## IN THE DRAWINGS

Please amend the drawings as follows:

**FIG. 2**

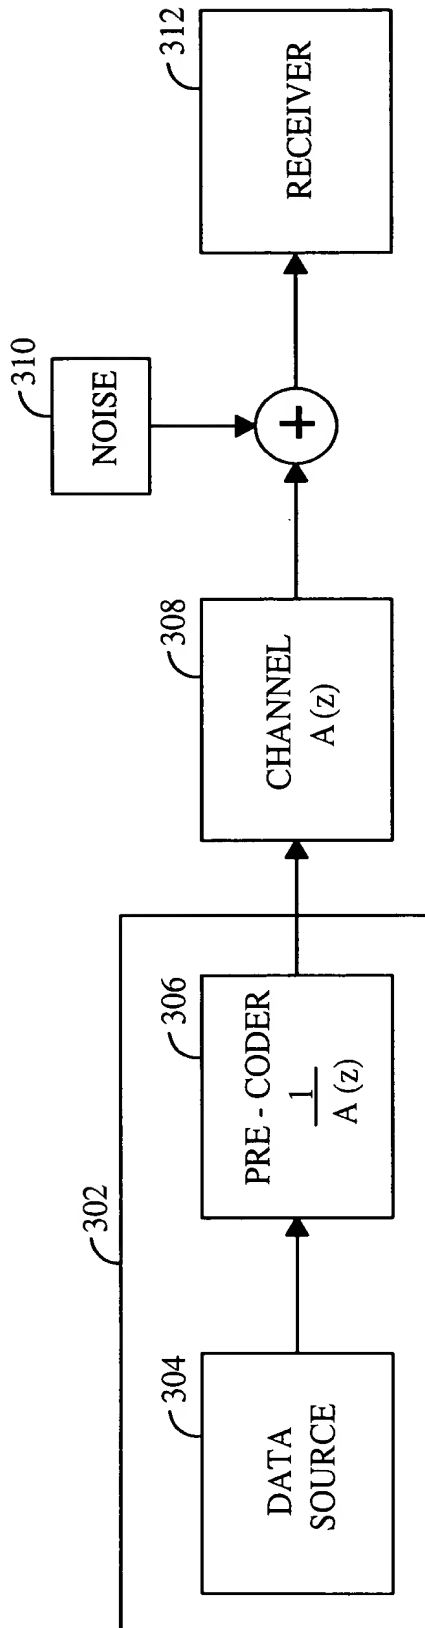
Specifically, Applicant amends FIGs. 2, 3, 4, and 9 to correct minor typographical errors. FIGs. 2, 3, and 9 have the argument of the function "A()" changed to the discrete complex variable "z" instead of the mistyped "2" in the original drawings. FIG. 9 also has the equalizer transfer functions corrected to be  $H1(z)$  and  $H2(z)$  consistent to the specification. FIG. 4 has the label added for communication system **400** consistent to paragraph [1028]. The name of element **412** in FIG. 4 was inadvertently omitted. This element has been labeled "controller." Paragraph [1035] in the specification as originally filed refers to "the controller **412**." Hence, this correction does not constitute new matter.

800

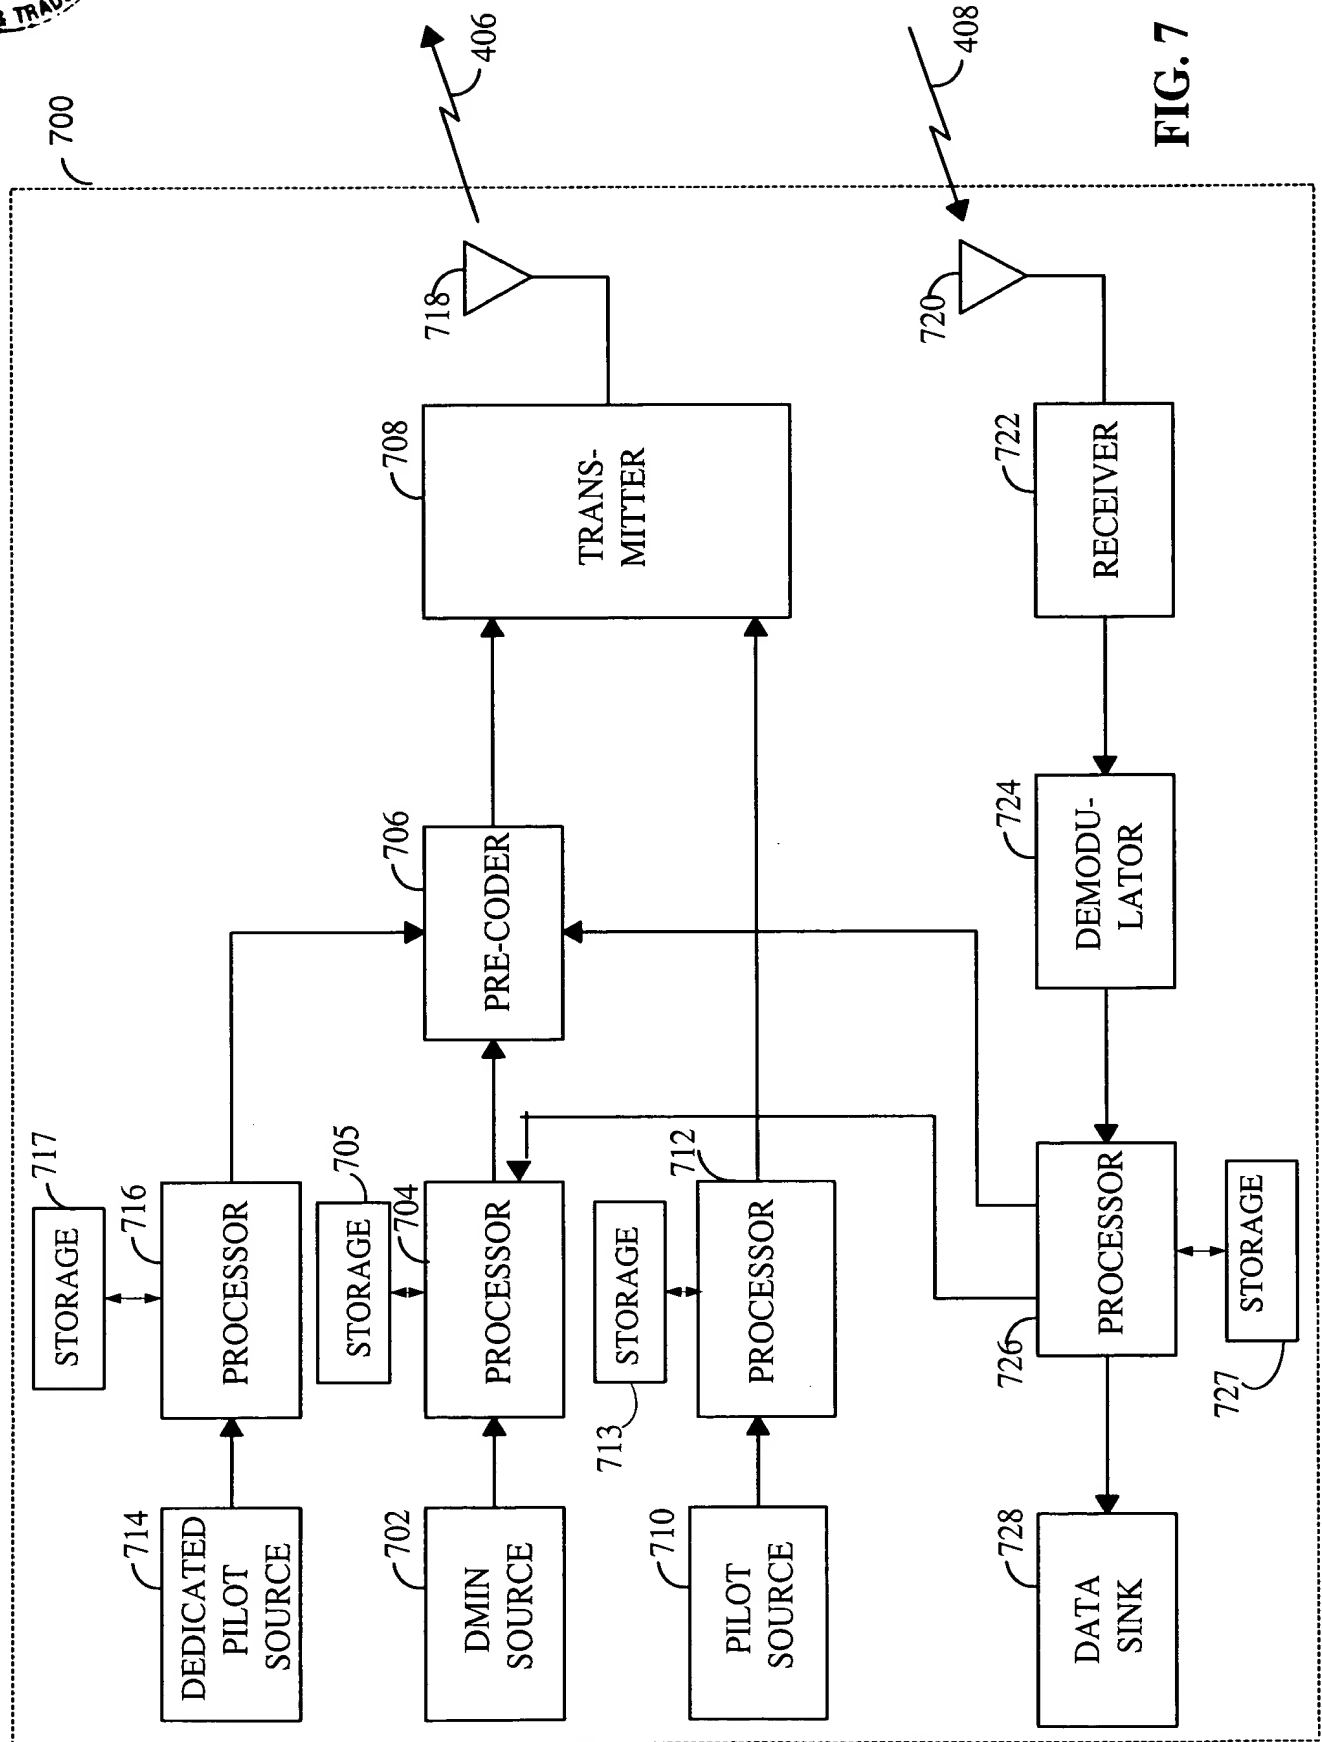
FIGs. 7 and 8 are amended to have storage attached to all processors to comply with examiner's objection that the drawings must show every feature of the invention specified in the claims. Applicant states that the addition is not new matter because digital processing and computation inherently involves some sort of storage, either separately or distributed among the processing elements, or both. Further paragraph [1059] in the original specification discusses various storages media that can be coupled to the processor.
